Metro Martin Place

Over Station Development Design Integrity Report

North Site

JUNE 2020

SSD: Approved Drawing Modification

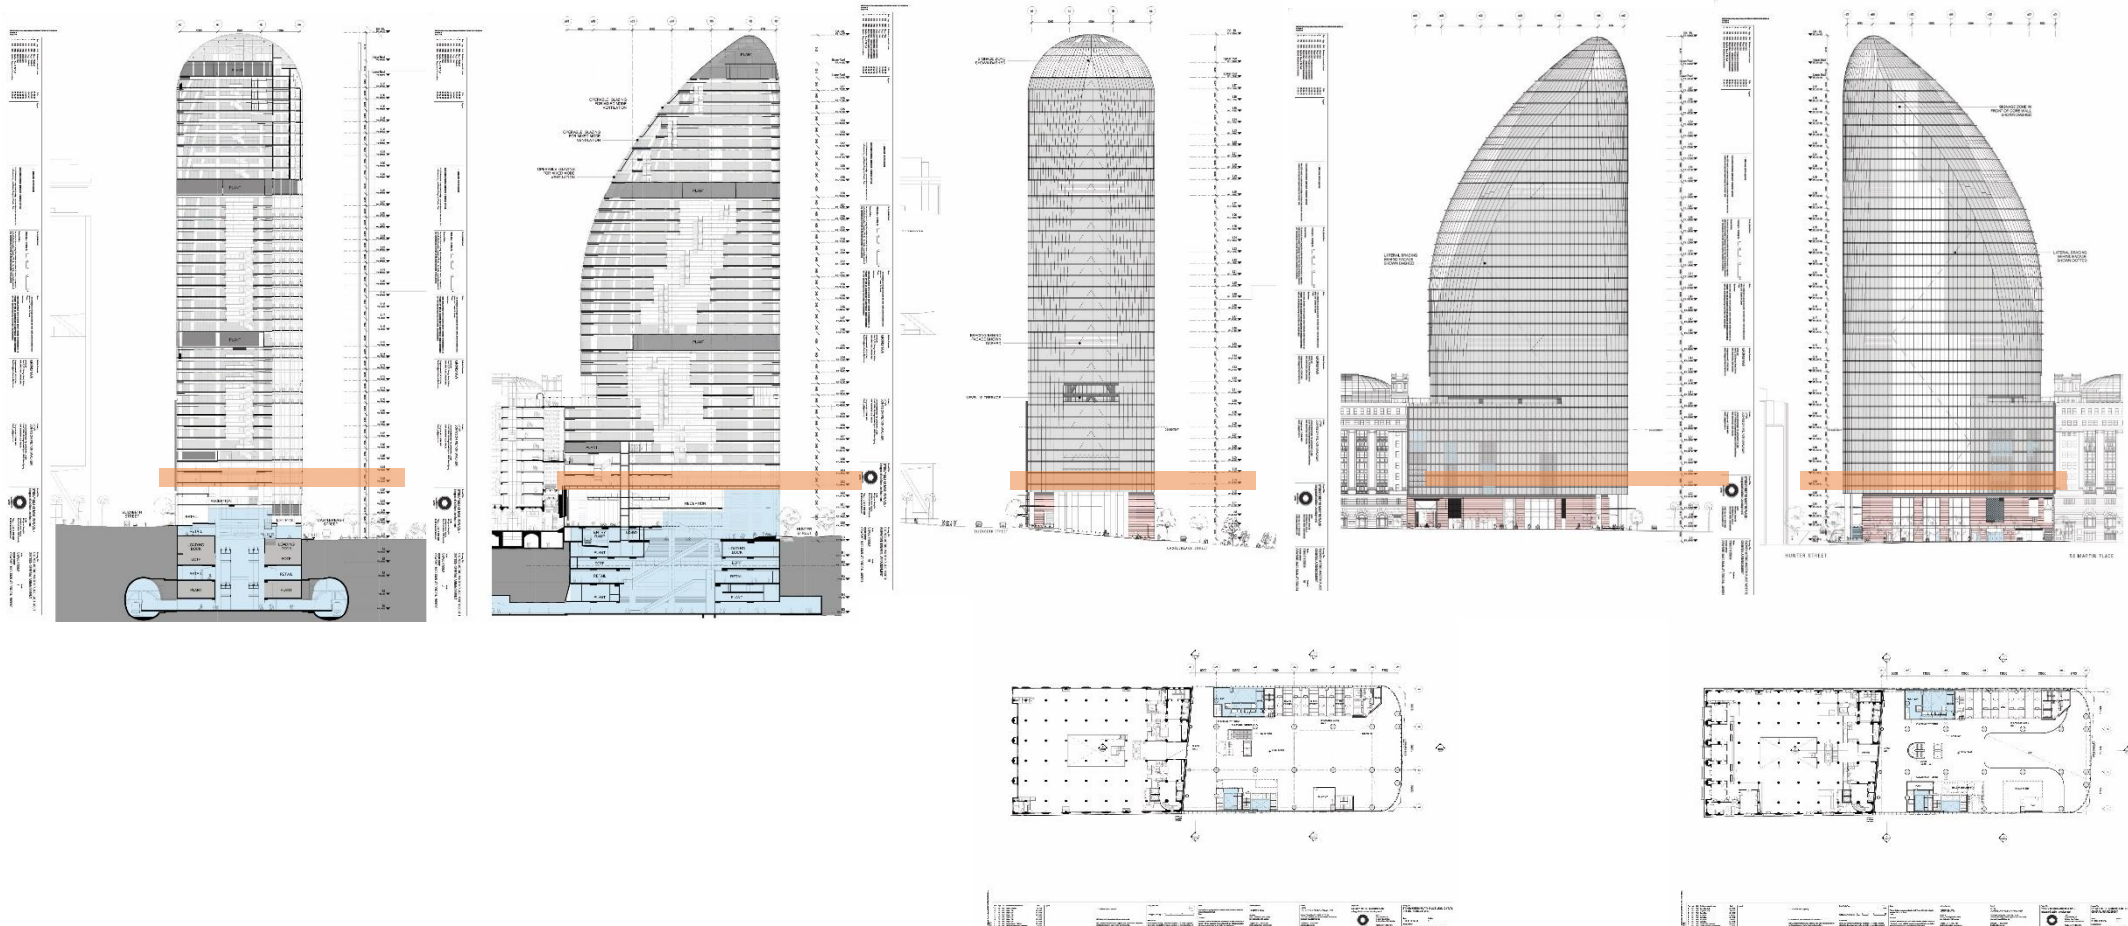
Raised service access floor to Levels 3 & 4

The panel supports the change, noting there is no discernible impact to the approved project.
